**MARION TOWNSHIP
ZONING BOARD OF APPEALS**

- 1) ZBA Case # 02-17 – Chestnut Development – Pinckney Road Vacant Land
Tax ID# 4710-24-100-004*

RE: 47-10-24-100-004, Chestnut Creek Drive (private road)

RE: Chestnut Creek PR# 01-16
Marion Township, Livingston County, MI

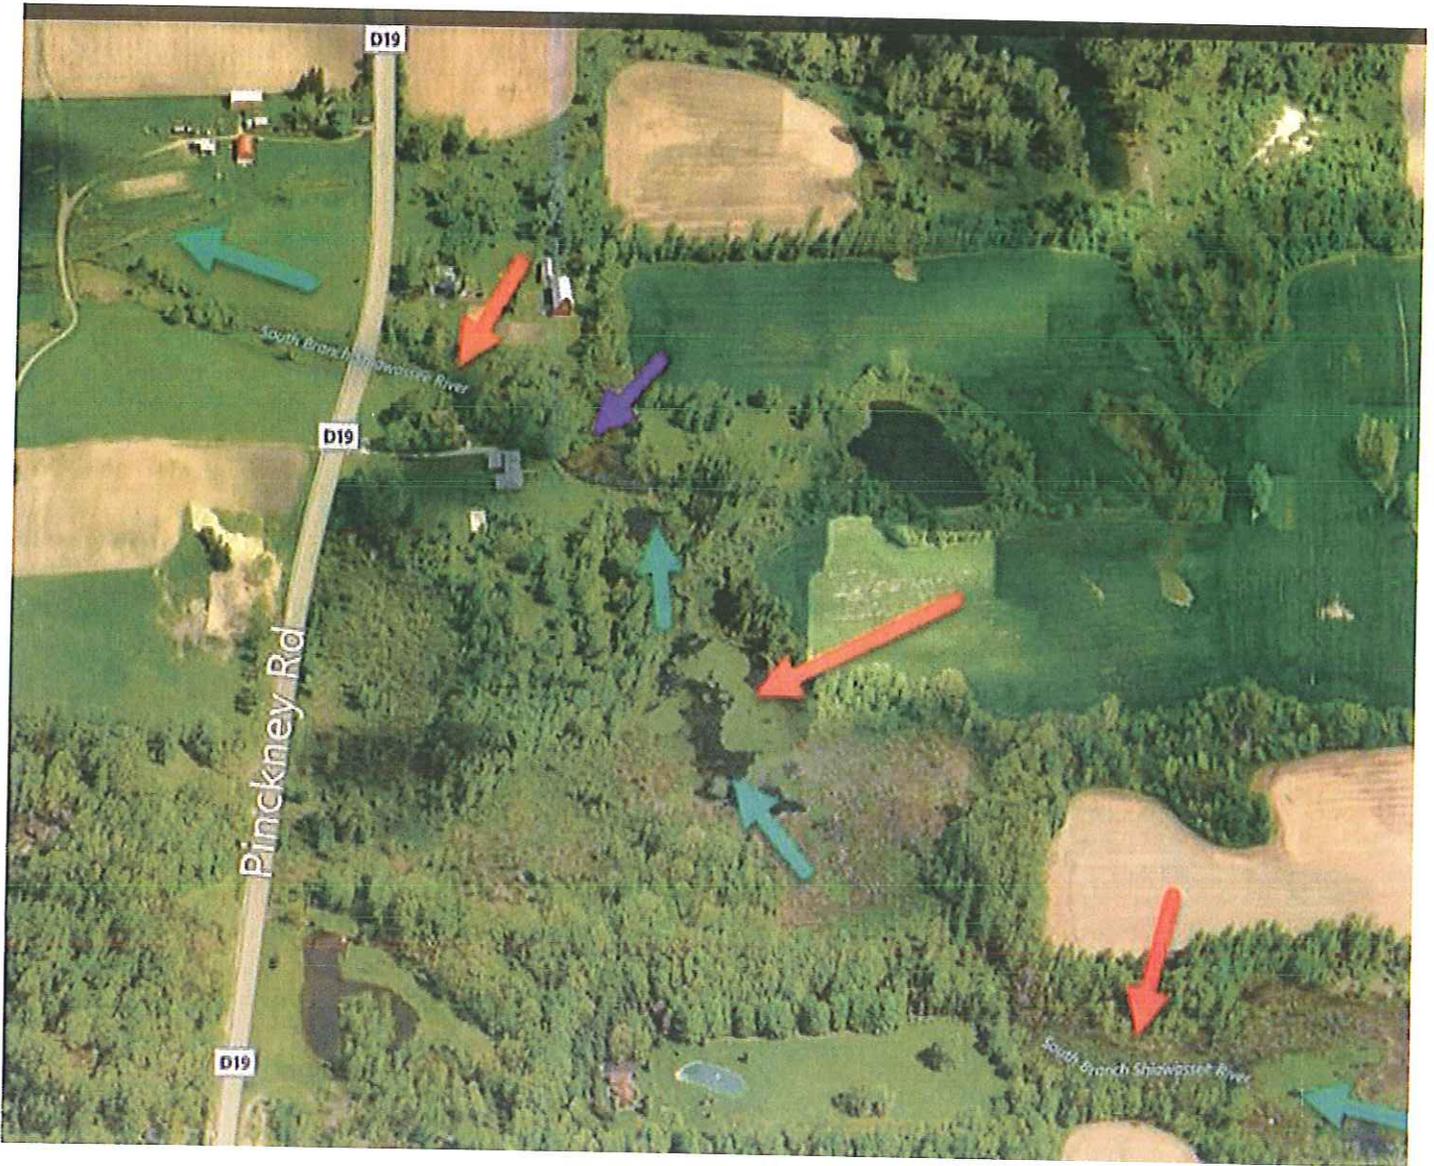
Hi Mark – I'm concerned about a road serving up to 12 single family homes being so close to a major power pole. The center line of the proposed access road is about 15 feet from the pole. I think they are attempting to protect the pole by installing large (2 feet x 2 feet stacked two high) concrete blocks close to the pole. The proposed private road is the only access point to the development so all the construction equipment and materials will be brought in passing very close to the pole.

The attached file is the section of the plans near the power pole. It almost looks like the pole is in the blocks.

What are your thoughts on the isolation distance and adequacy of protection?

Are there specific design standards for isolation distances between private roads and power poles? On the plans the centerline of the proposed road is about 20 feet from the pole and they are proposing installing something called "bin blocks" that appear to be 2 foot concrete blocks placed against the pole.

This is more of an elevation change. If the proposed grade change doesn't violate NESC clearances to the utility lines and the blocks are kept about 5ft from pole, no issue with DTE.
